Community Association Letter

From: [Renfrew Planning](#)
To: [McLeod, Fraser A.](#)
Cc: [Renfrew President](#)
Subject: [EXT] Re: LOC2018-0201 - Circulation Package
Date: Monday, October 15, 2018 6:17:06 PM
Attachments: [image.png](#)
[image.png](#)
[image001.png](#)

LOC 2018-0201 (1101 Russet Road NE):

DP 2018-4442 (1101 Russet Road):

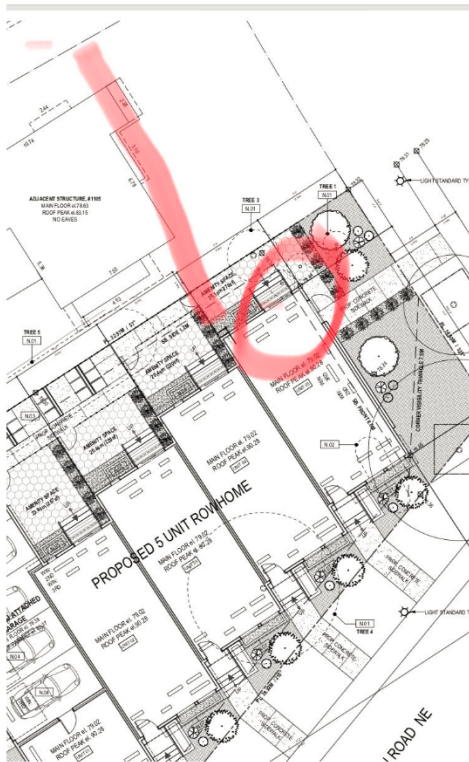
However, there are several difficult parts of this design. Most importantly, the building poorly addresses Russet Road, its height and massing is a serious concern, and residents generally do not approve of its appearance.

The height and massing is a concern. At a maximum of 11.94m, this is almost 12m, the maximum height of M-CG, albeit with a lower lot coverage. This causes concerns about overlooking and privacy, especially due to 25 windows on the second and third floors facing the neighbour to the North at 1105 Russet Road. Also, because Russet Road runs generally North-South, the shadow caused by this project will fall largely on 1105 Russet Road. Given that one of the objects of the Renfrew Community Association is "generally to encourage and foster and develop among its members a recognition of the importance of agriculture in the national life," we do not want to keep the residents of 1105 from growing anything in their yard. While we do not normally fight to preserve front set backs because front yards tend to be used only for lawn mowing, Russet Road's North-South course means that this unit's shadow into the 1105's front yard will also prevent it from being used for anything more productive than growing lawn. There are likely streets in Renfrew where this height would be appropriate but this is not one of them. We look forward to the North Hill Local Growth Plan helping us decide where and how buildings of this height fit best.

Our primary suggestion is to make this a four unit rowhouse, retaining the home designed partially above the garage. Each garage stall would be larger, and more effective. This could also reduce the height and bring it to R-CG's maximum. Height could also be reduced by reducing the ceiling height, lowering the basement so the main floor is level with the yard (making the homes more accessible), or both.

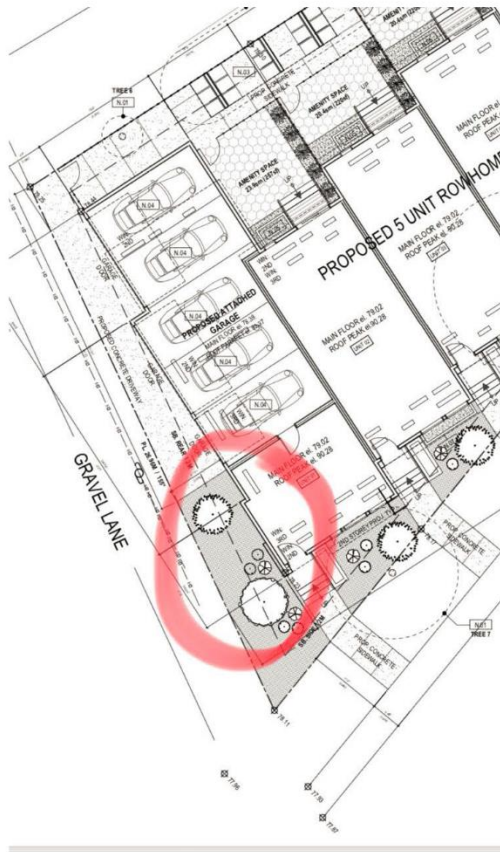
More thought needs to go into the unit closest to Russet Road (labelled unit number 5). Unit 5's design makes the entire home turn its side and back to Russet Road. Russet Road is a gateway to the neighbourhood. Thus, unit 5, because it protrudes past the front facade of 1105, needs to be attractive from all three sides. This is shown in the drawing below.

Having identical floorplans saves money but the unit 5 should be the most valuable unit and warrants a separate design to maximize its location's value and treat the neighbours using the sidewalk and street more respectfully. With more thought, it would be possible for unit 5's main entrance to be on Russet Road. With minor changes to the design, windows could be added to the east elevation. On the main floor, they could be above the stove; on the second floor, each bedroom could have East-facing windows if both closets were on the West side of the room; on the third floor, the bedroom could also have a window above where a bed would likely go. This could be further improved by placing the entrance on Russet Road.

The other units' amenity spaces act as a buffer between 1101 and 1105. Given the lot configuration, unit 5 loses the benefit of a larger backyard amenity space. We ask that unit 5 be made shallower to provide at least the same amount of backyard amenity space as unit 4 has (by bringing the north wall in line with unit 4's north wall).
